FT4690R2 Hydraulic level sensor defective

Manual section 09

MQR 7621-1684

Removal Of Hydraulic Oil Level Sensors

Figure 4 – Hex Head Plug

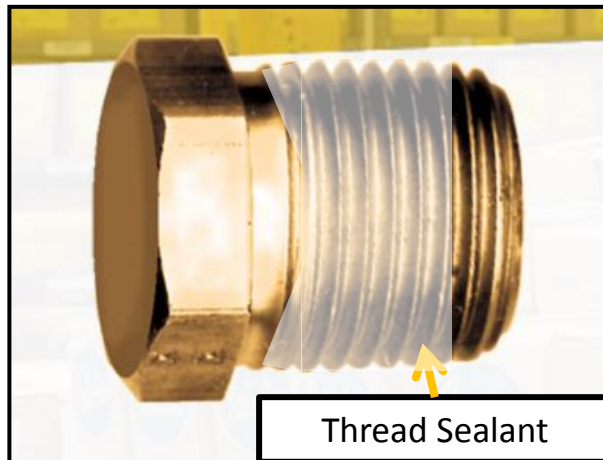
3. Spray on an even amount of Loctite Thread Activator 7649 onto the threads of the brass plug (P/N 0444620). Allow to air dry. Next, apply a bead of Loctite 565 thread sealant (P/N N37086) onto male threads of hex head brass plug (P/N 0444620) starting two threads from the end (see figure #4).
4. Unscrew and remove the oil sensor from the hydraulic oil tank (see figure #5). (Return the removed hydraulic oil level sensor wire kit to Prevost.)

Figure 6 – Hex Head Plug Insertion

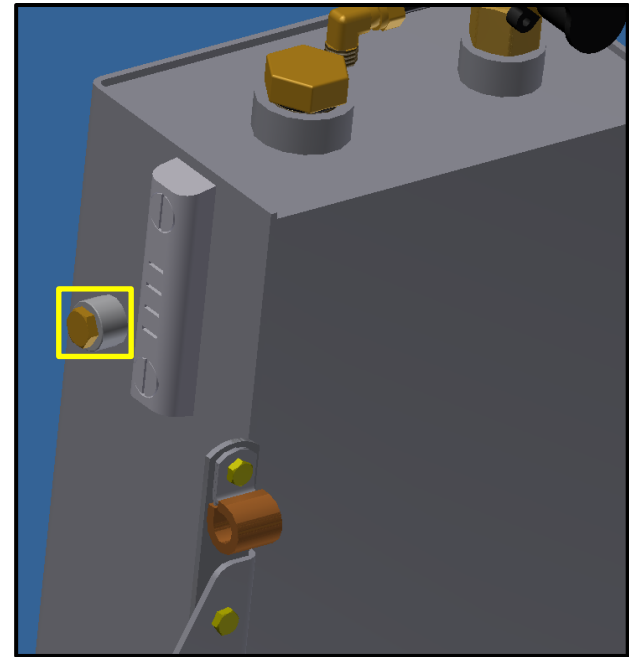
5. Use a clean rag or cloth to catch any fluid that may escape the hydraulic oil tank sensor threaded hole.
6. Immediately insert hex head brass plug into the hole and quickly fasten it finger tight (see figure #6).
7. Torque to 2 turns past finger tight using an appropriate wrench.
8. Apply torque seal bead once tightened.

10. DEUTSCH CONNECTOR SCENARIO (P/N N31229-04)

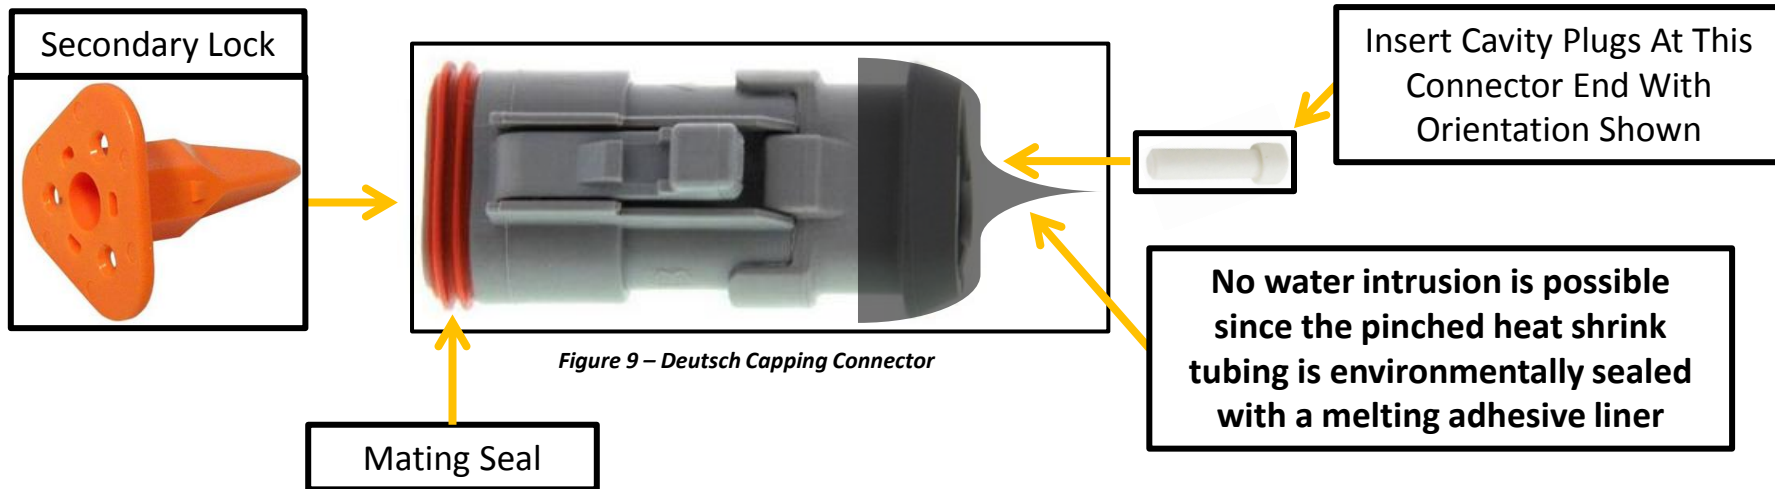
- Insert a secondary lock to prevent the mating seal from falling (P/N N25892-03).
- Seal each of the 3 cavities with a cavity plug (P/N N11681).
- Install 1.5 inch of heat shrink tubing (P/N N82227-13) over the capping connector shrink boot adapter located on the wire entry side. Then seal the connector end by pinching the heat shrink tubing with pliers while heating (see figure #9).
- Plug the capping connector on the mating harness #64 breakout (+EN-X64HF).

Figure 10 – Modified Harness #64 Breakout (+EN-X64H□)

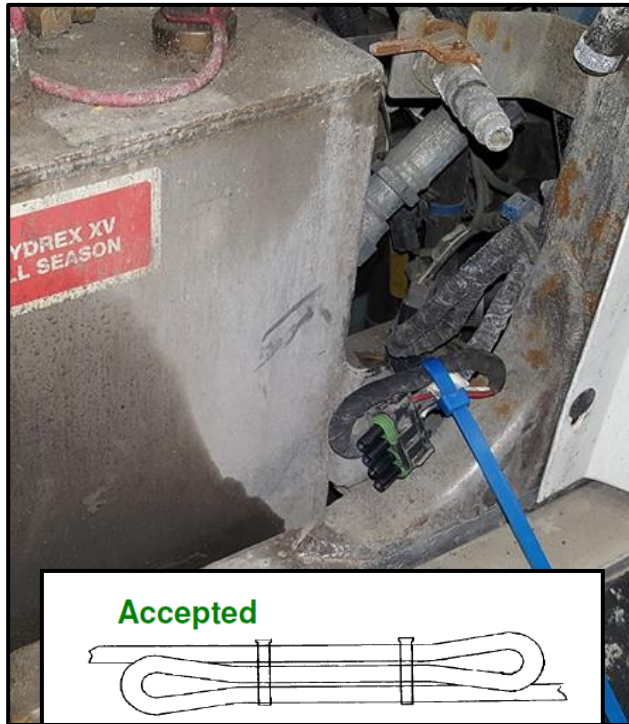
11. Use a zip-tie (P/N N56339) to properly stow and secure harness breakout (+EN-X64H□) as shown in the following pictures (see figures #10 and #11). Connector could be Deutsch or Delphi variant depending on build configuration.
